BCC DS
RECEIVED
06/10/2026
APPLICATION REF
A007111411

OVERALL FLOOR PLAN - BASEMENT

1 THEODORE ST, STAFFORD

Drawing Title.
OVERALL FLOOR PLAN - LEVEL 1 (GRD)

Drawing Title.
BLOCK 01
ELEVATIONS

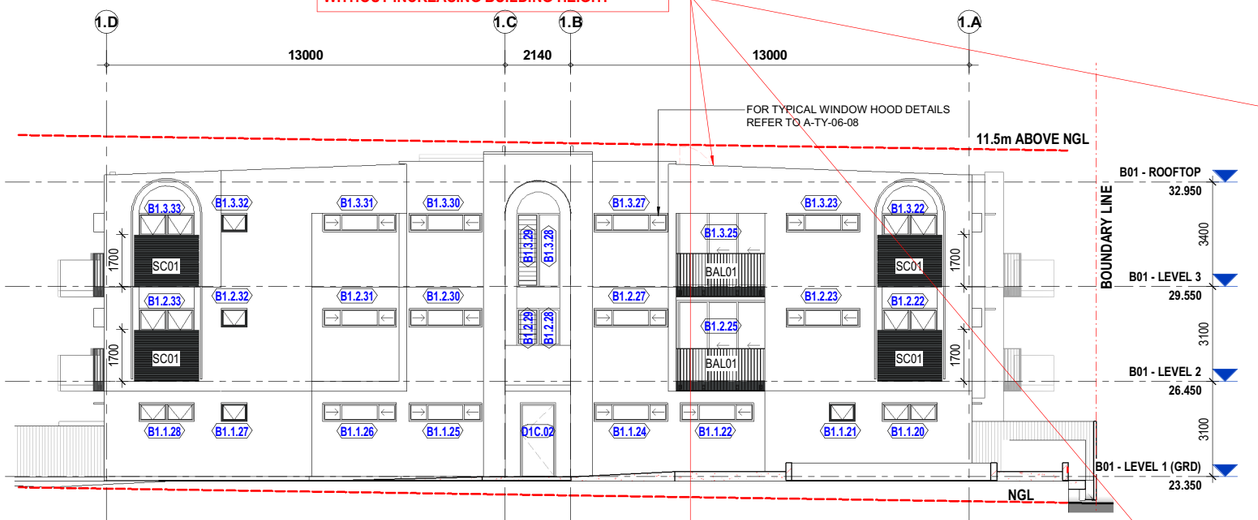
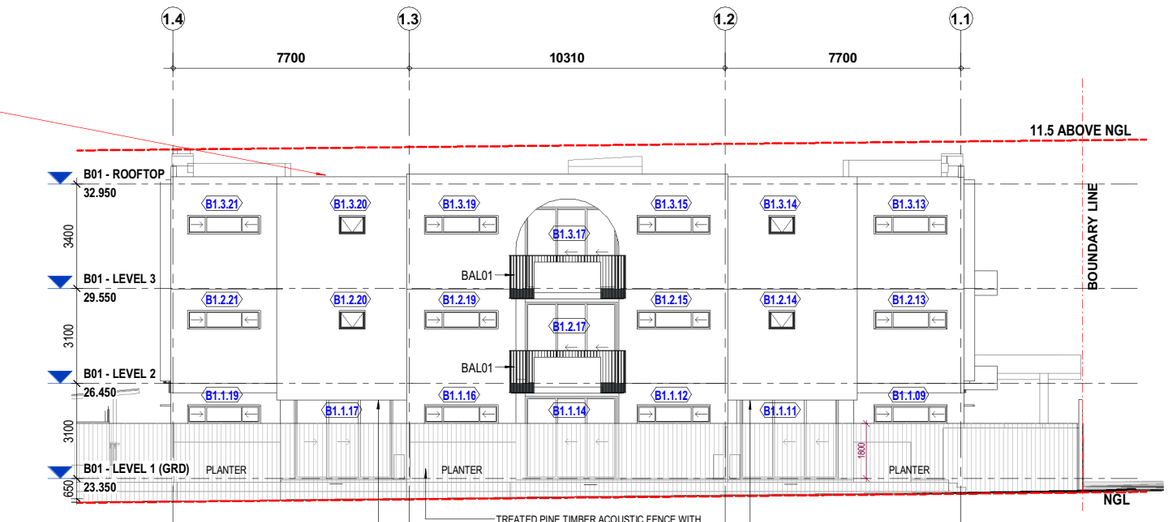
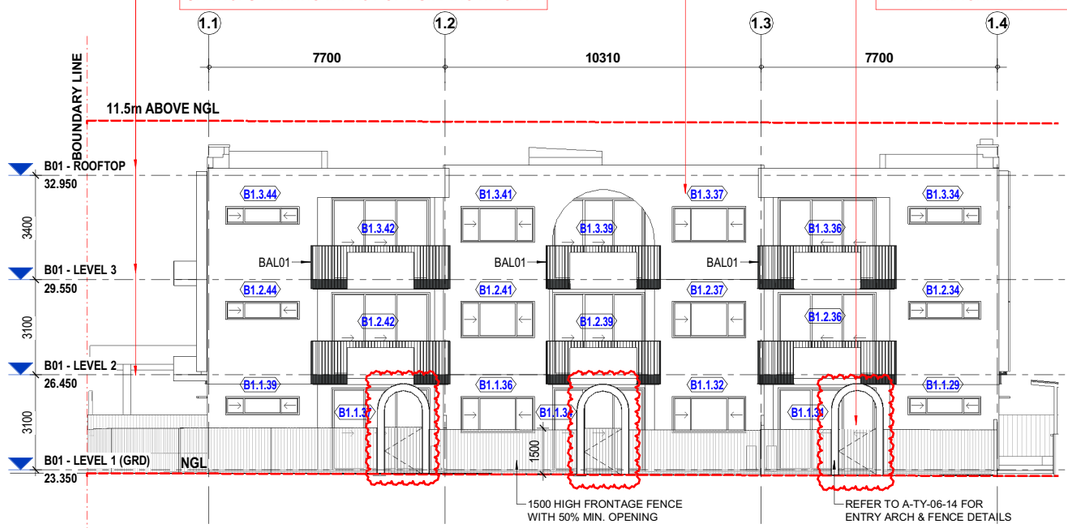
CHANGE OF PITCHED ROOF TO FLAT ROOFTOP WITHOUT INCREASING BUILDING HEIGHT

DASHED GREEN LINES SHOW BLOCK OUTLINE AS PER APPROVE DA

RAISED LEVELS TO ACCOMMODATE CEILING SERVICES WITH NO IMPACT OF BUILDING HEIGHT

REVISED TYPICAL GATE DESIGN FOR BETTER ALIGNMENT WITH FACADE ARCHES

REDUCED WINDOW HEIGHT

Drawing Title.
BLOCK 02
ELEVATIONS

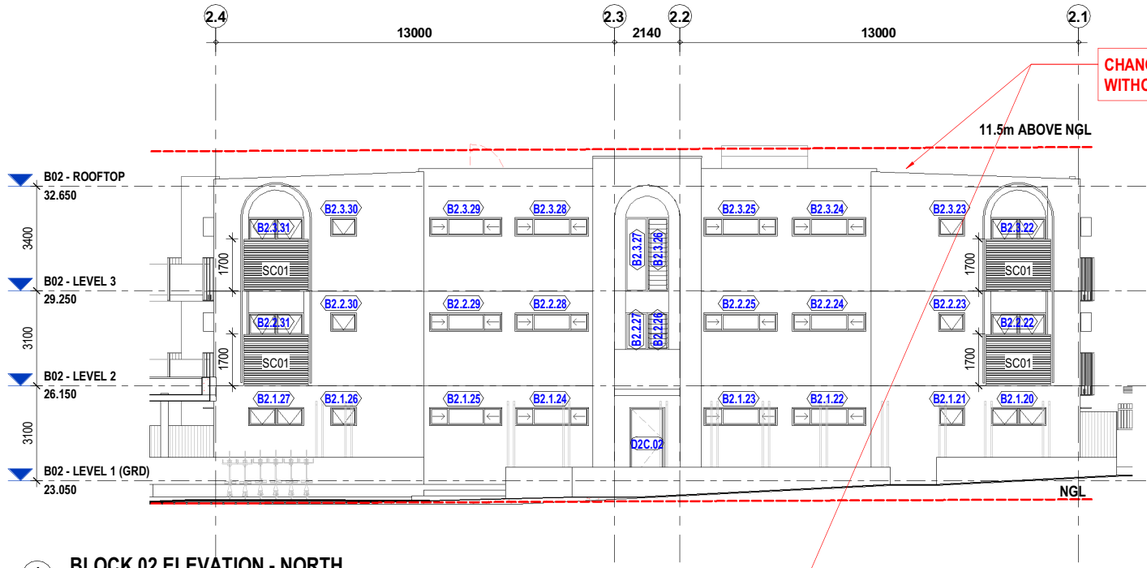
DASHED GREEN LINES SHOW BLOCK OUTLINE AS PER APPROVE DA

REVISED TYPICAL GATE DESIGN FOR
BETTER ALIGNMENT WITH FACADE ARCHES

Drawing Title.
BLOCK 03
ELEVATIONS

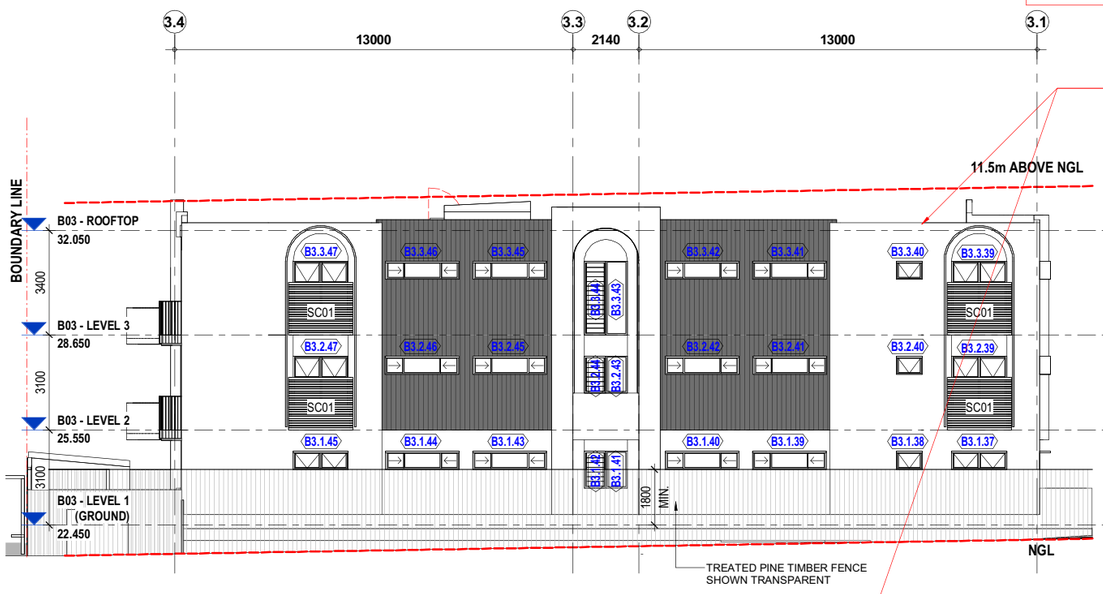
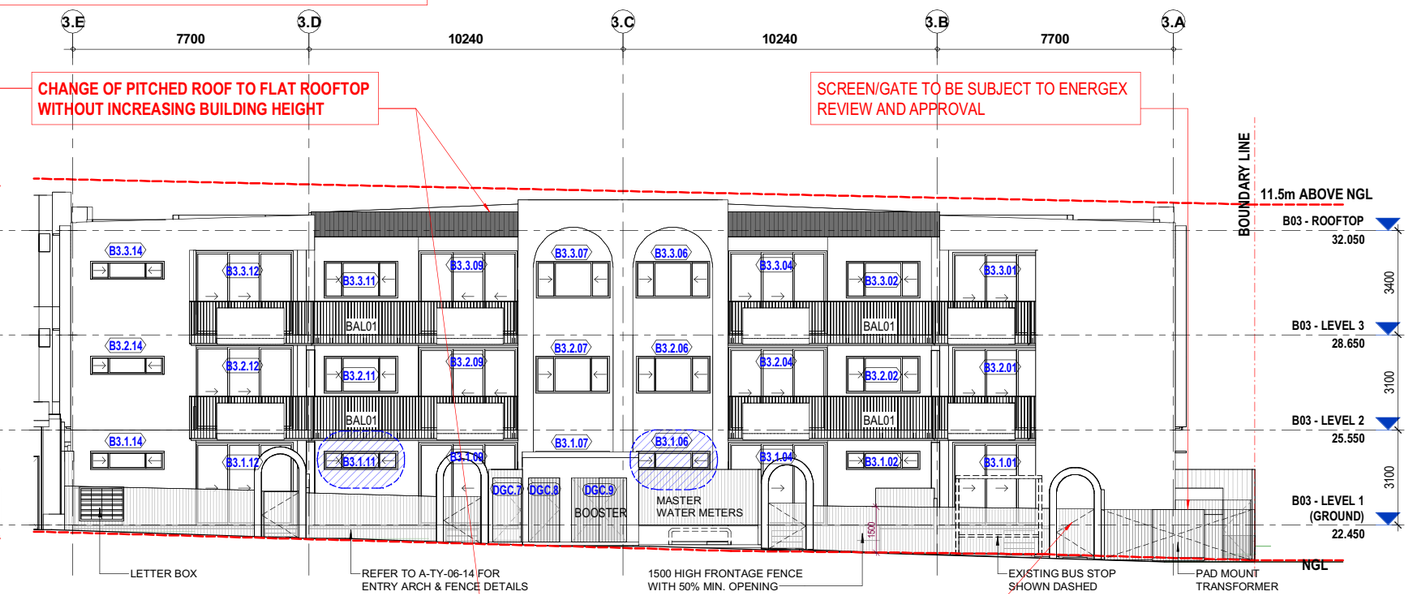
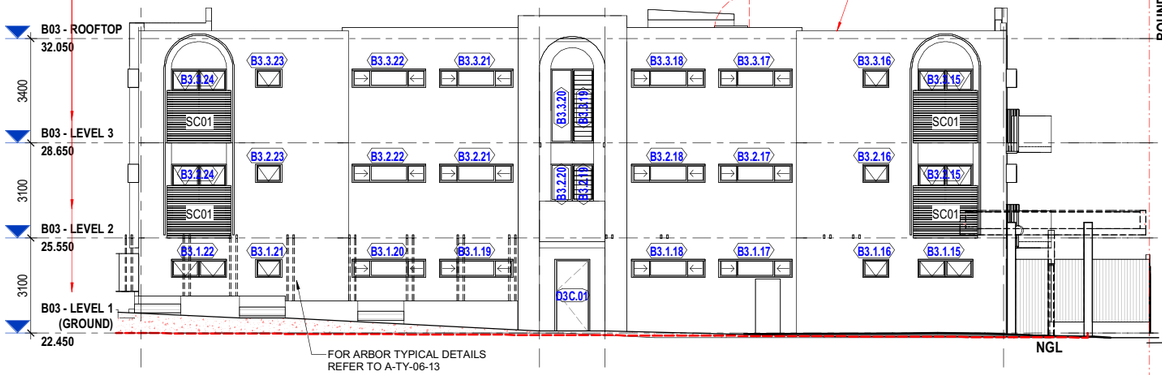
DASHED GREEN LINES SHOW BLOCK OUTLINE AS PER APPROVE DA

CHANGE OF PITCHED ROOF TO FLAT ROOFTOP WITHOUT INCREASING BUILDING HEIGHT

SCREEN/GATE TO BE SUBJECT TO ENERGEX REVIEW AND APPROVAL

RAISED LEVELS TO ACCOMMODATE CEILING SERVICES WITH NO INCREASE IN BUILDING HEIGHT

REVISED TYPICAL GATE DESIGN FOR BETTER ALIGNMENT WITH FACADE ARCHES
